**BUNCOMBE COUNTY
GENERAL SERVICES DEPARTMENT
40 McMORMICK PLACE
ASHEVILLE, NC 28801
(828) 250-4235**

BID DATE: Monday, November 20, 2023
DATE OF ADDENDUM: Thursday, December 14, 2023
ADDENDUM NUMBER: A

**SPORTS PARK - NEW RESTROOM BUILDING &
WATERLINE EXTENSION
BUNCOMBE COUNTY, NORTH CAROLINA**

Sheet
C2

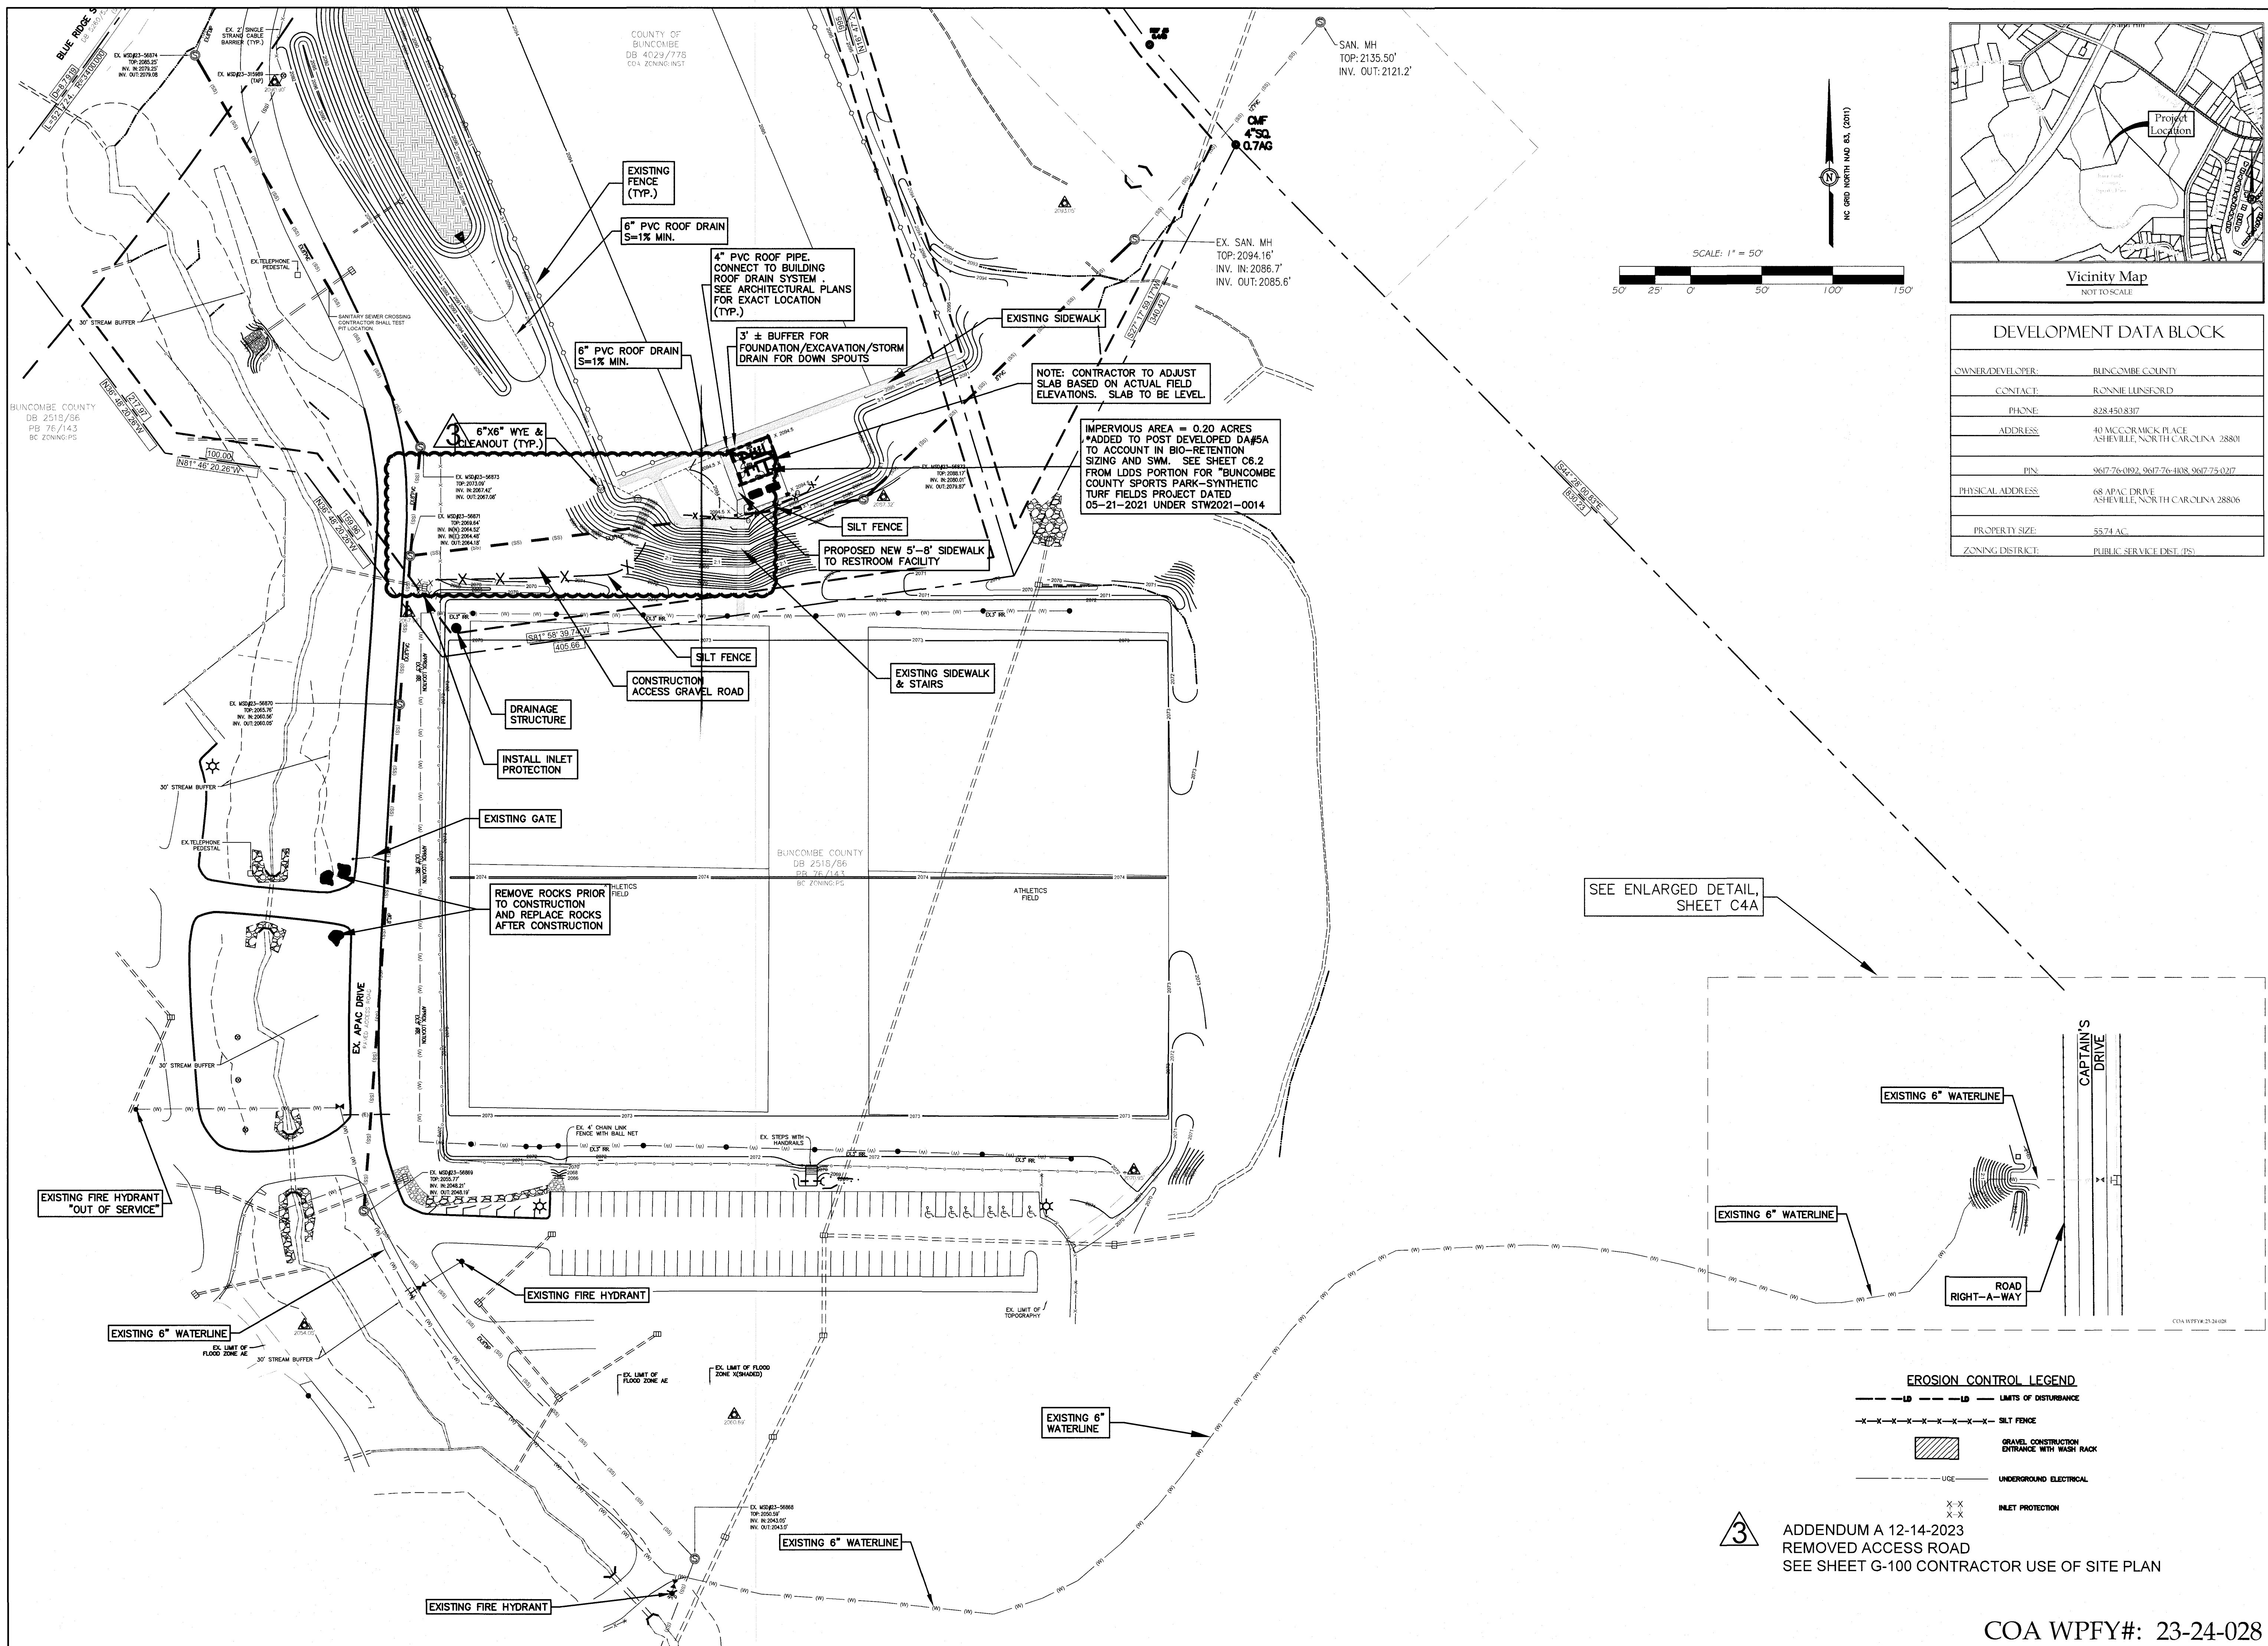
- Item 1 - **Revised (C2)**. Remove “Construction Access Gravel Road” shown on the west side of the proposed restroom facility. The Construction access is shown on sheet G100 in the Contractor Use of Site Plan and is to run parallel to the east side of the field.

3 ADDENDUM A 12-14-2023
 REMOVED ACCESS ROAD
 SEE SHEET G-100 CONTRACTOR USE OF SITE PLAN

**Grading, Stormwater,
 and Erosion Control**

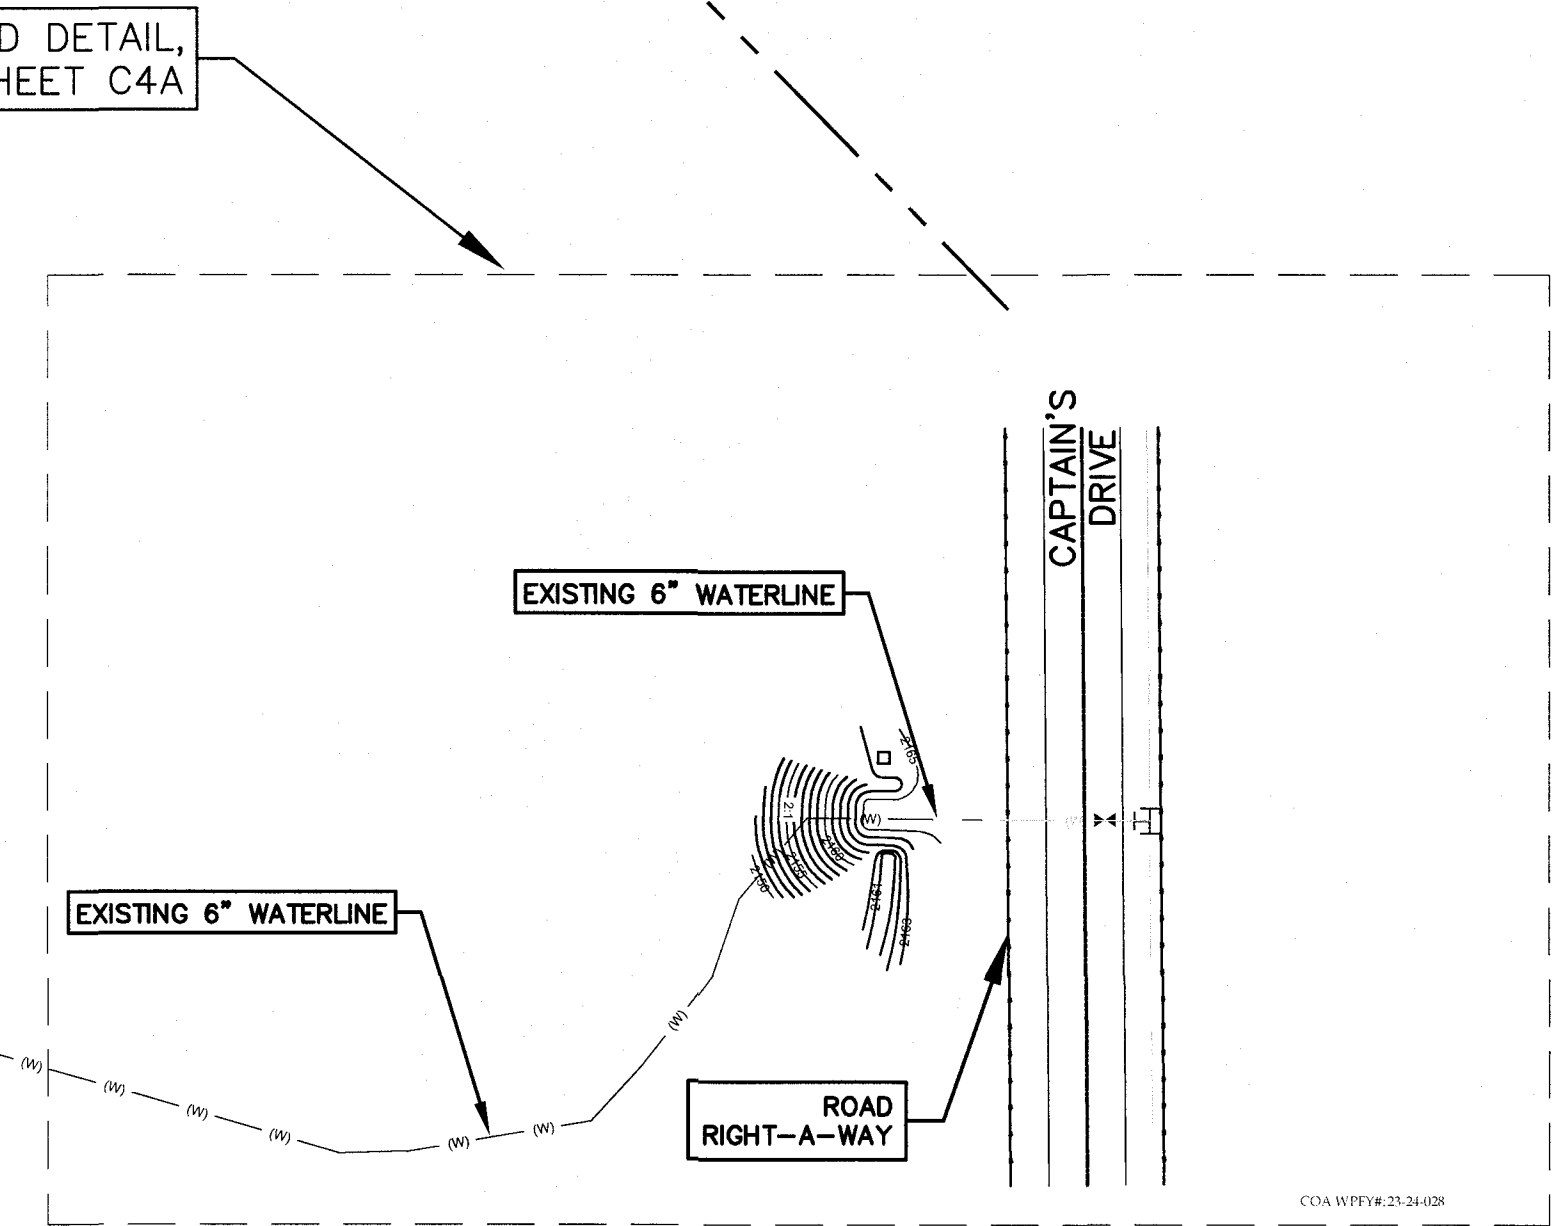
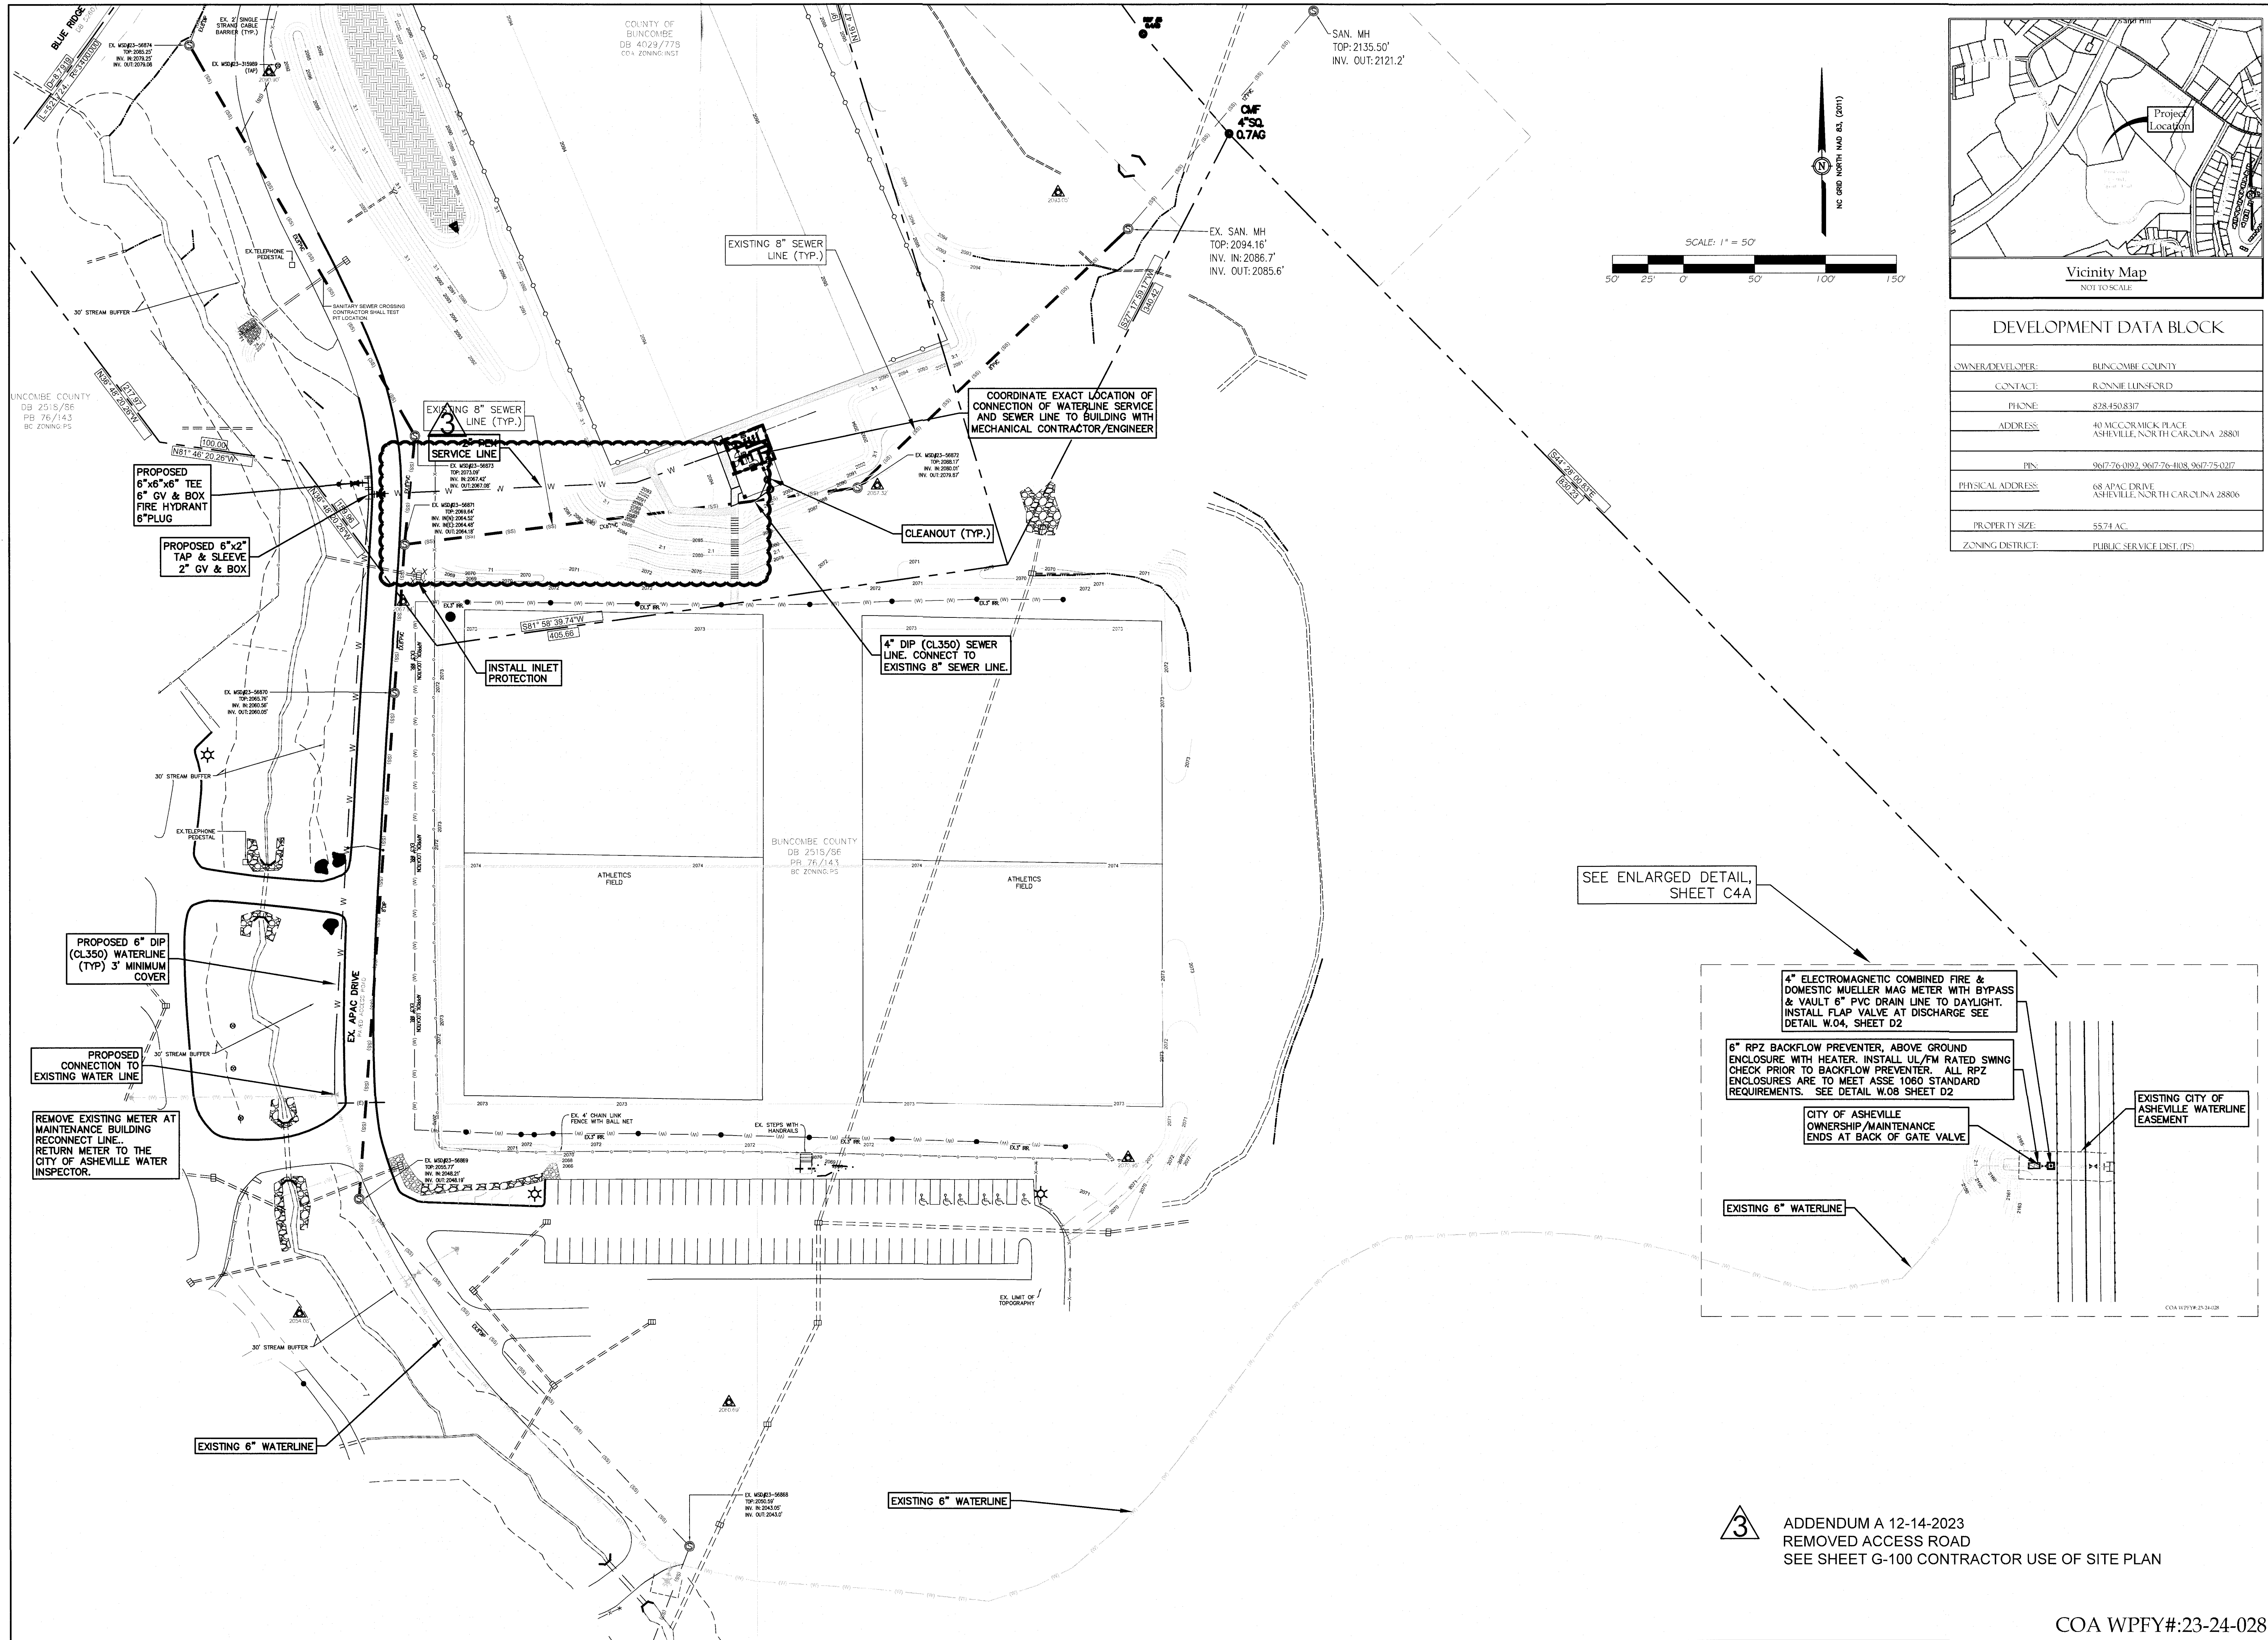
- Item 2 - **Revised (C3)**. Remove “Construction Access Gravel Road” shown on the west side of the proposed restroom facility. The Construction access is shown on sheet G100 in the Contractor Use of Site Plan and is to run parallel to the east side of the field.

3 ADDENDUM A 12-14-2023
 REMOVED ACCESS ROAD
 SEE SHEET G-100 CONTRACTOR USE OF SITE PLAN
